# Access Compliance Report

## Public Rights-of-Way

### (Curb Ramps)

Intersection ID: 27900	Main Street: FROHOCK_PL	Cross Street: HARRISON'S_CROSSING_AV	Location: SE
ADA ID: 166DCC12700A	Ramp Type: BlendTrans2	Initial Pass/Fail: Fail	Overall Compliance: No
		Severity Score: 10

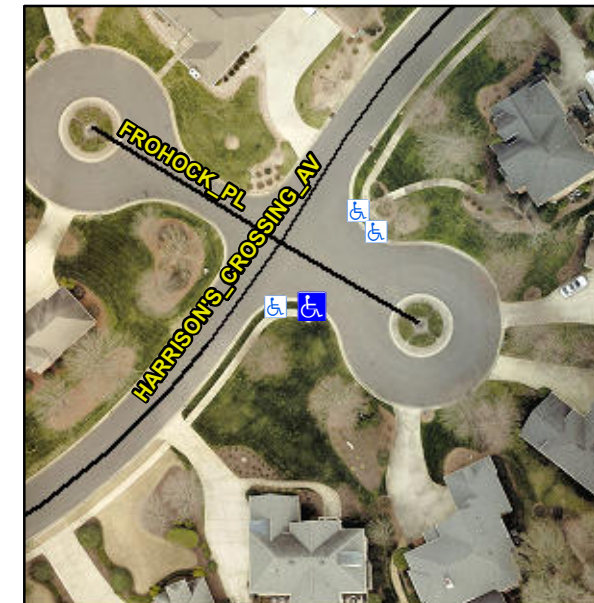
**Not Found, R304.5.1, R304.5.3**

Compliance	Description	Data	Compliance	Description	Data
N/A	Ramp Length (in)	98.0	Yes	BlendTrans Slope (%)	1.6
No	Ramp Width (in)	44.0	No	BlendTrans XSlope (%)	2.5
N/A	Flare Type LT	N/A	N/A	Flare Type RT	N/A
N/A	Flare Slope LT (%)	N/A	N/A	Flare Slope RT (%)	N/A
N/A	Flare Traversable LT?	N/A	N/A	Flare Traversable RT?	N/A
N/A	Landing Length (in)	N/A	N/A	DWS Provided?	N/A
N/A	Landing Width (in)	N/A	N/A	DWS Contrast?	N/A
N/A	Landing Slope (%)	N/A	N/A	DWS Length (in)	N/A
N/A	Landing X Slope (%)	N/A	N/A	DWS Full Width?	N/A
N/A	Landing Curb? (Y/N)	N/A	N/A	DWS Offset (in)	N/A
N/A	Shared Landing?	N/A			
N/A	Gutter Ponding?	N/A	N/A	Gutter Slope (%)	N/A
N/A	Gutter Lip Ht (in)	N/A	N/A	Gutter X Slope (%)	N/A
N/A	Painted X Walk1?	No	N/A	Painted X Walk2?	N/A
	X Walk 1 Direction	To NE		X Walk 2 Direction	N/A
	X Walk 1 Width (in)	N/A		X Walk 2 Width (in)	N/A
	X Walk 1 Slope (%)	4.4		X Walk 2 Slope (%)	N/A
	X Walk 1 X Slope (%)	0.9		X Walk 2 X Slope (%)	N/A

N/A	Ramp inside XWalk1?	N/A	N/A	Ramp inside XWalk2?	N/A
	Road Slope (%)	0.9		Clear Space?	N/A
	Road X Slope (%)	4.4	N/A	Clear Space to XWalk (in)	N/A
N/A	Any Obstructions?	N/A	N/A	Storm Grate/Utility Hazard?	N/A
	Obstruction Type			Storm Grate/Utility Type	
		N/A			N/A
			Yes	Surface Condition? (G/P)	Good
			No	Curb Slope (%)	9.8

**Remove & Replace Curb Ramp With Two New Directional Ramps or Equivalent.**
